March 20, 2025

Director Dan Victoria
Department of Planning and Zoning
Fremont County
615 Macon Avenue
Cañon City, CO 81212

RE: Holcim (US) Inc. CUP 24-001 Red Creek Quarry
Response to Deficiencies and Comments

Figure 2
Red Creek Quarry and Materials Transport and Access Corridor
Waterway Crossings

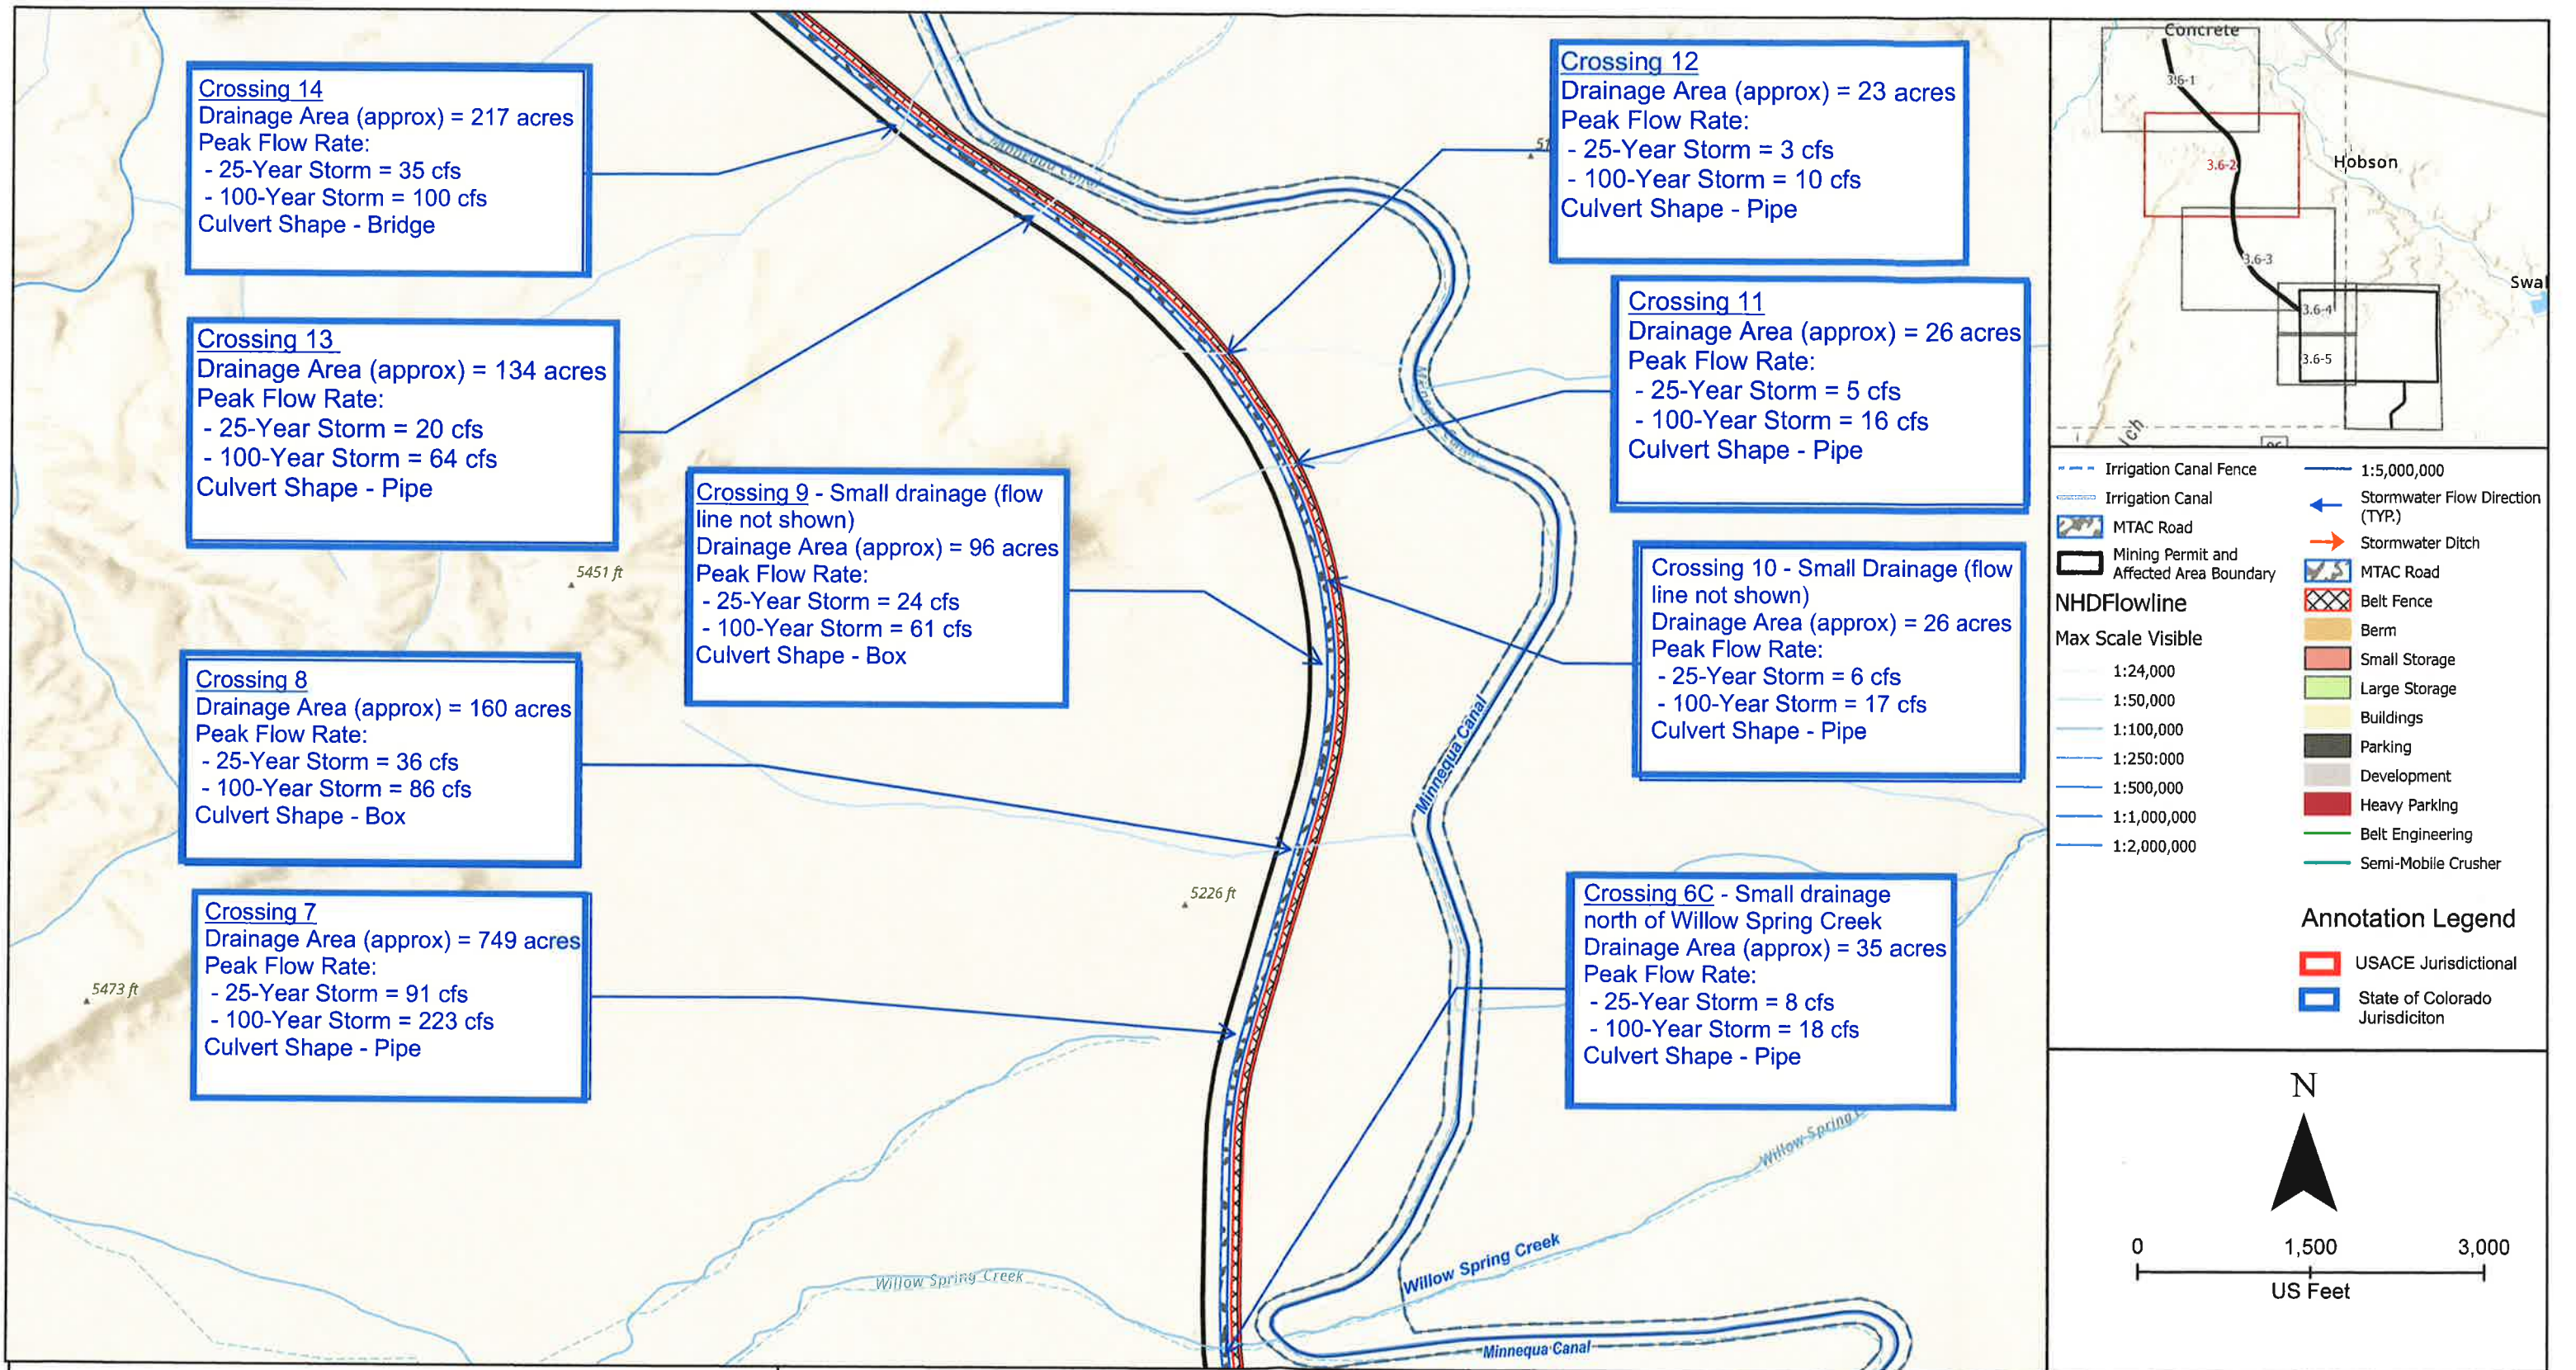
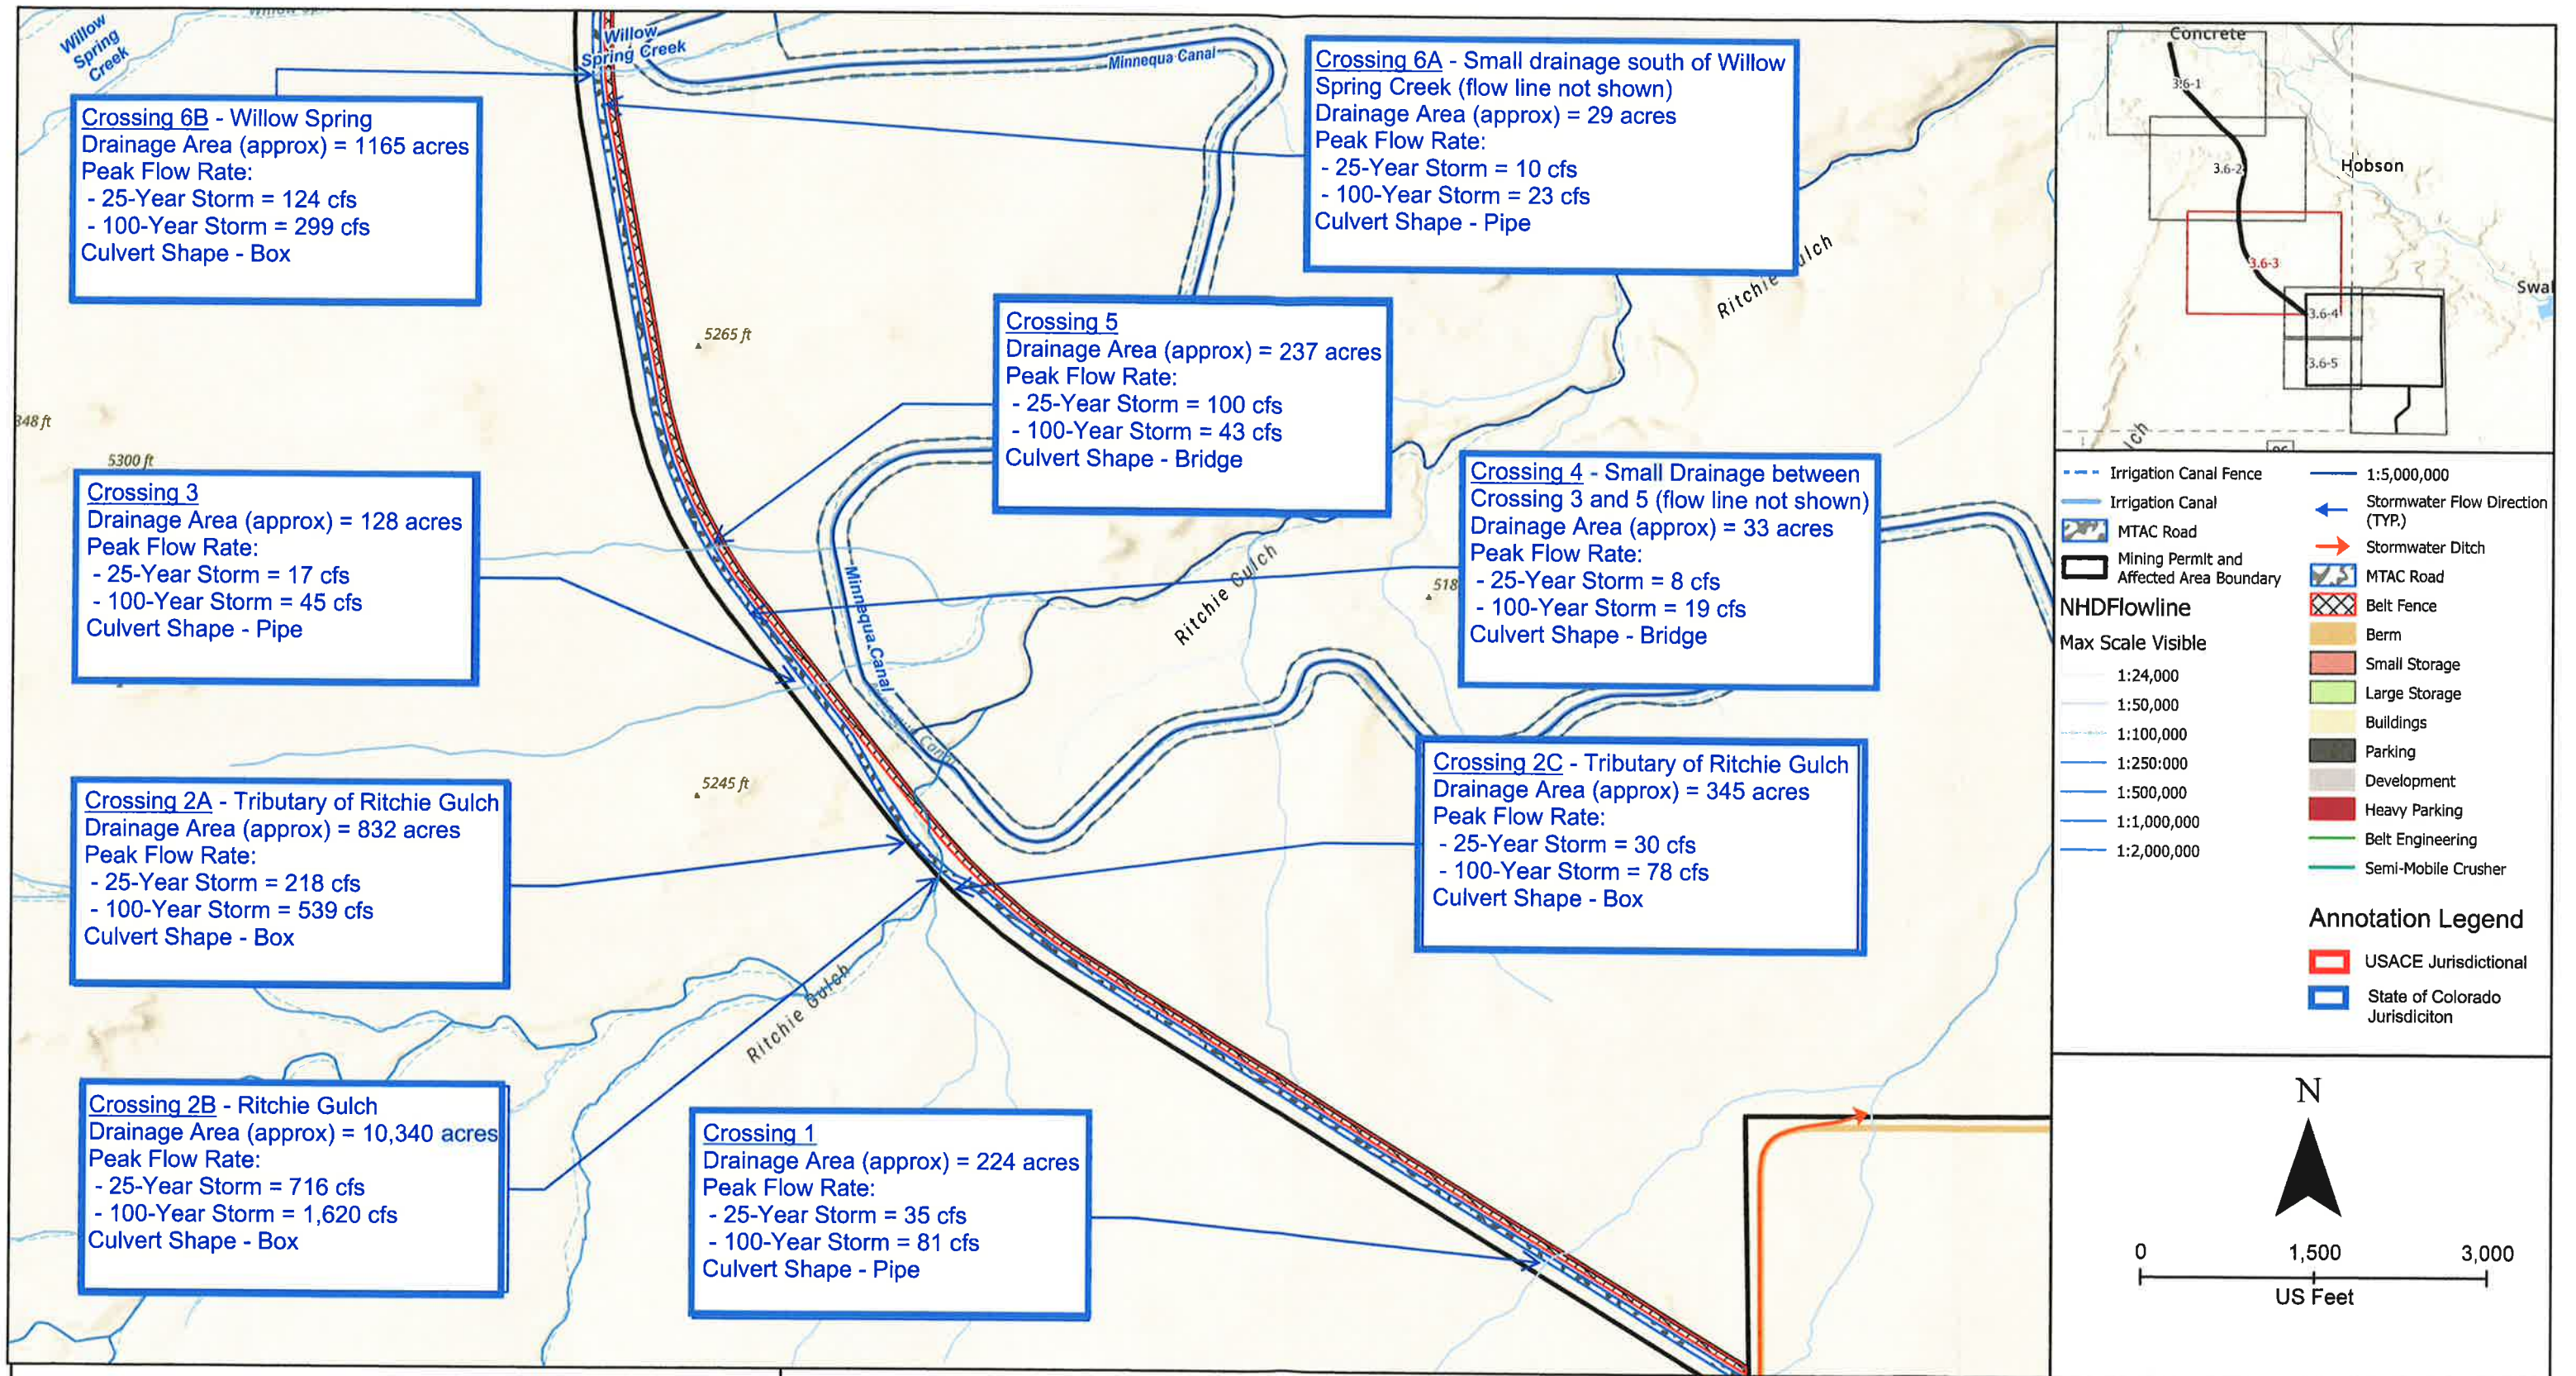
1. Site plan coding of ephemeral vs. USACE culverts/drainage structures is included in the Drainage Plan in Figure 2.
2. The conveyor and the roads will be elevated over the Minnequa Canal at Ritchie Gulch. Siphons will not be constructed.
3. The RCQ operations facility drainage is detailed in Section 4.2 of the Drainage Plan.
4. Culvert slopes are discussed in Section 4.4 of the Drainage Plan.
5. Rip rap sizing is discussed in Section 4.5 of the Drainage Plan.
